Road Safety Audit Stage 1

Fontwell Avenue Bus Stop Works

Eastergate

Report Title Fontwell Avenue, Bus Stop Works, Road Safety Audit Stage 1

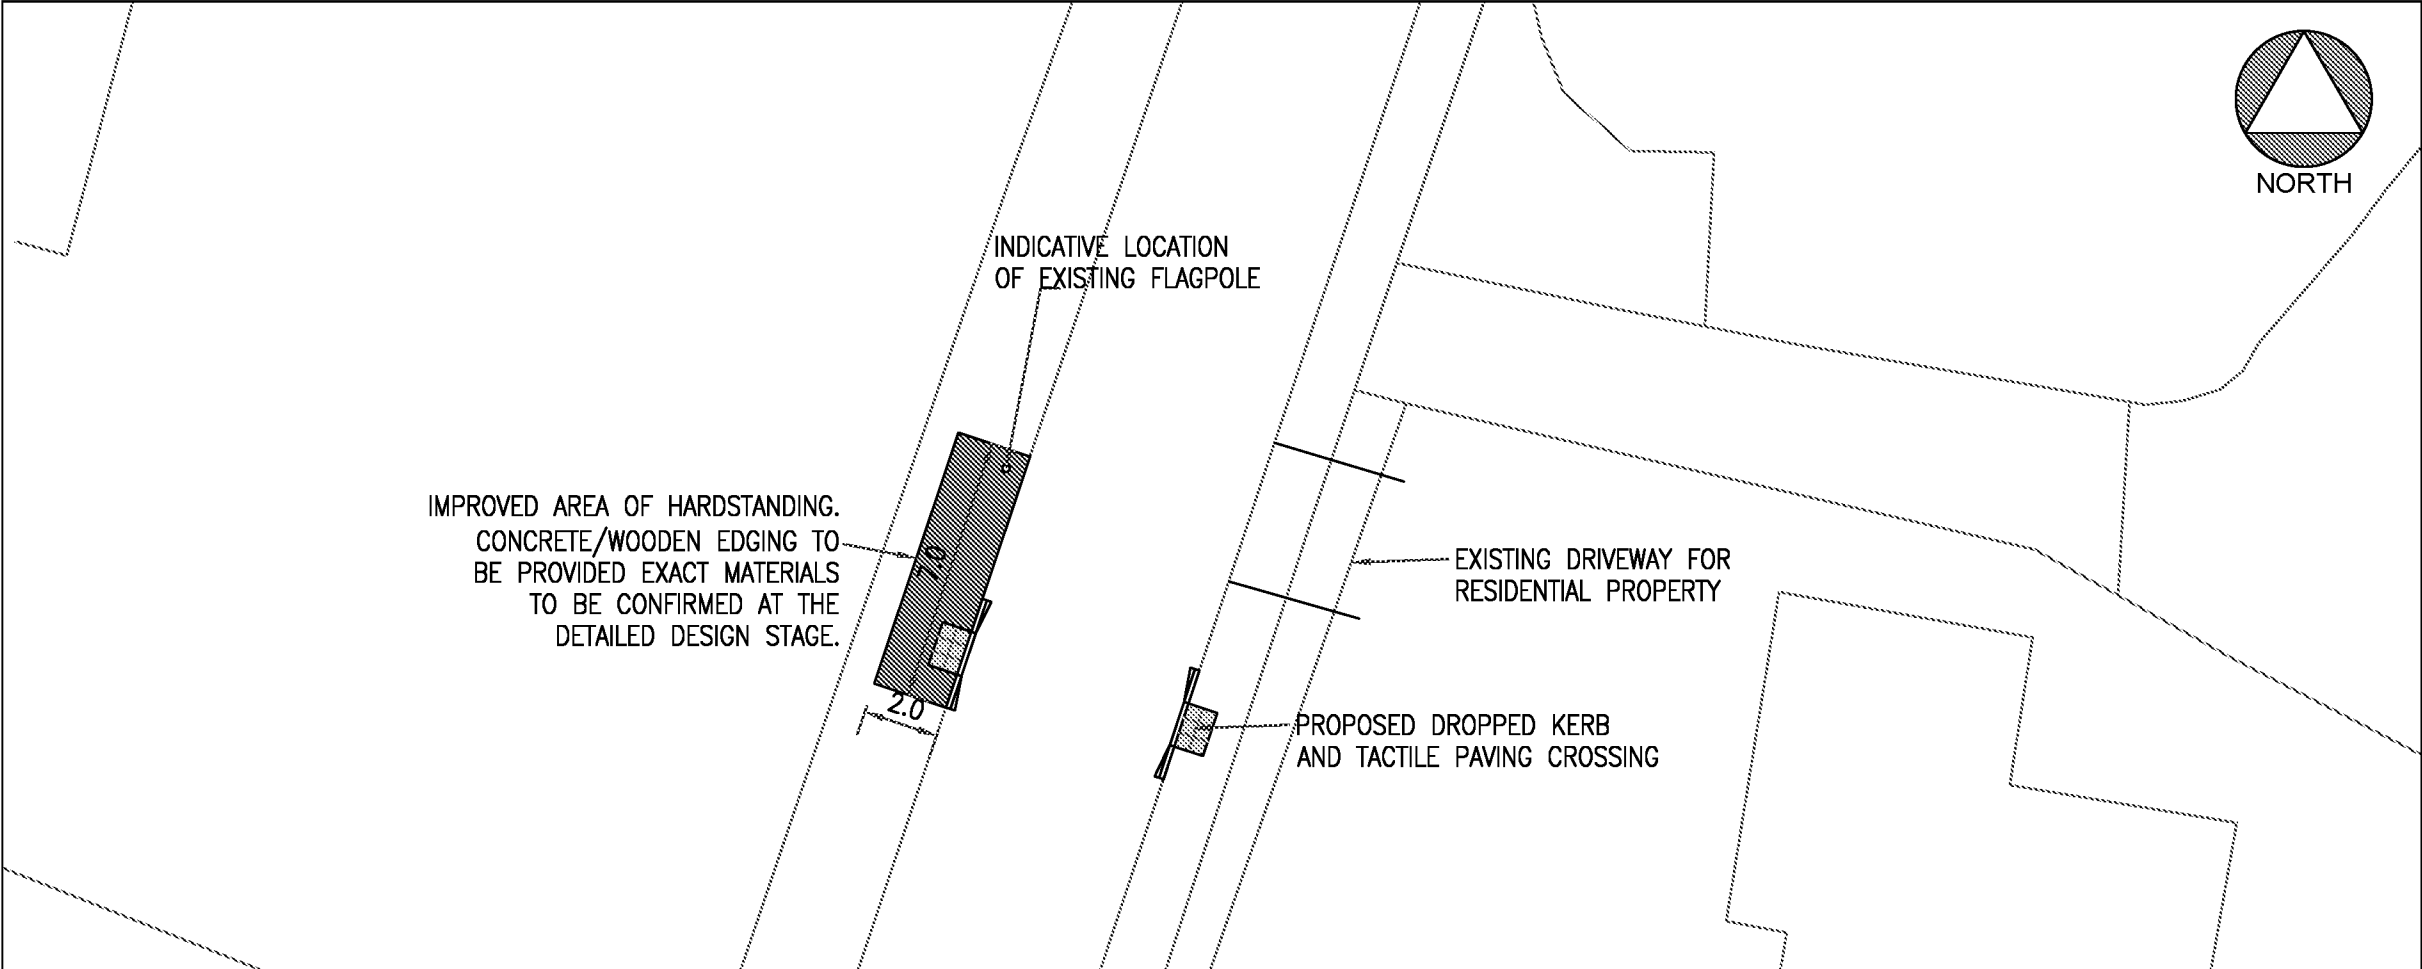
RSA Problem	RSA Recommendation	Design Organisation response)	Overseeing Organisation response	Agreed RSA action
3.4.1 Visibility splays have been shown at the crossing point, which are considered acceptable, however, in the southern visibility splay on the western side of the carriageway (at the bus stop position), the visibility splay is restricted by adjacent vegetation which could be worsened when the shrub is in leaf-see figure 1 in the report. Restricted visibility could lead to vehicle to pedestrian collisions, or sudden braking and rear end shunts.	It is recommended that the vegetation should be cut back and maintained.	The vegetation lies within the highway boundary and will therefore be maintained to ensure visibility.	Response agreed, vegetation can be cut back as part of bus stop works and maintained by LHA
